City of Sugar Hill Planning Staff Report DRB TCO 17-00287

SUBJECT TO: FROM: DATE: Planning Director Town Center Overlay District (TCO) Design Review Mayor and Council, <u>Design</u> Review Board Planning Director April 25, 2018 Tax Parcel: 7-292-142 First Avenue

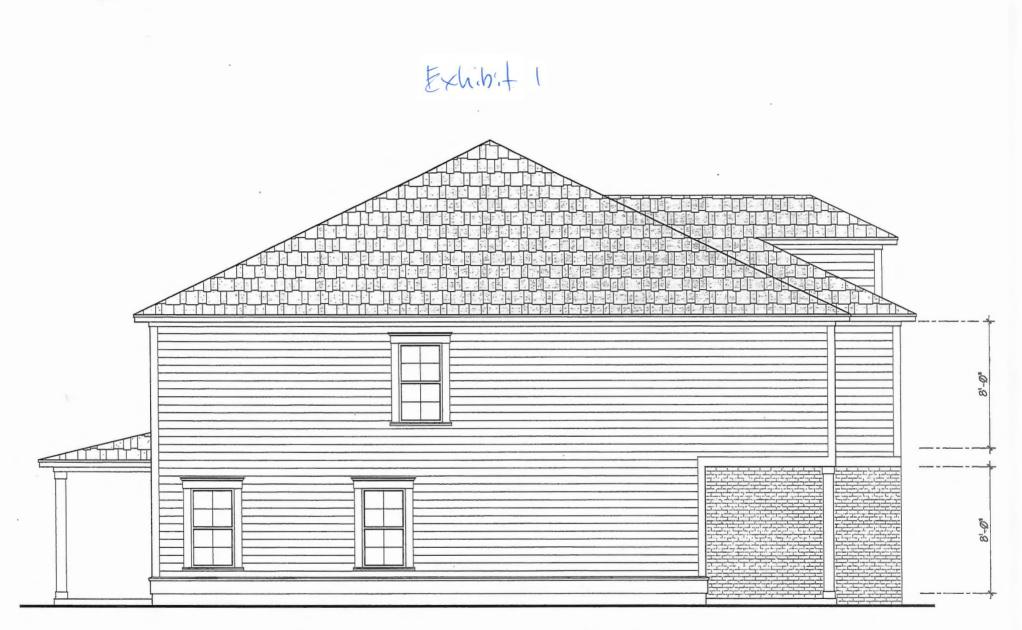
$\mathcal{G}$ Does the project contribute or resemble the following criteria for considering a design inappropriate? Character foreign to the area/ Violent contrasts of material or color, or intent or lurid colors / A

structure or surrounding area. multiplicicity or incongruity of details resulting in restless and disturbing appearance / The absence of unity and coherence in composition not in consonance with the density and character of the present

There are two newer duplexes nearby on First Avenue. This duplex, developed appropriately should be consistent with the area and continue the trend of redevelopment on First Avenue in a positive way.
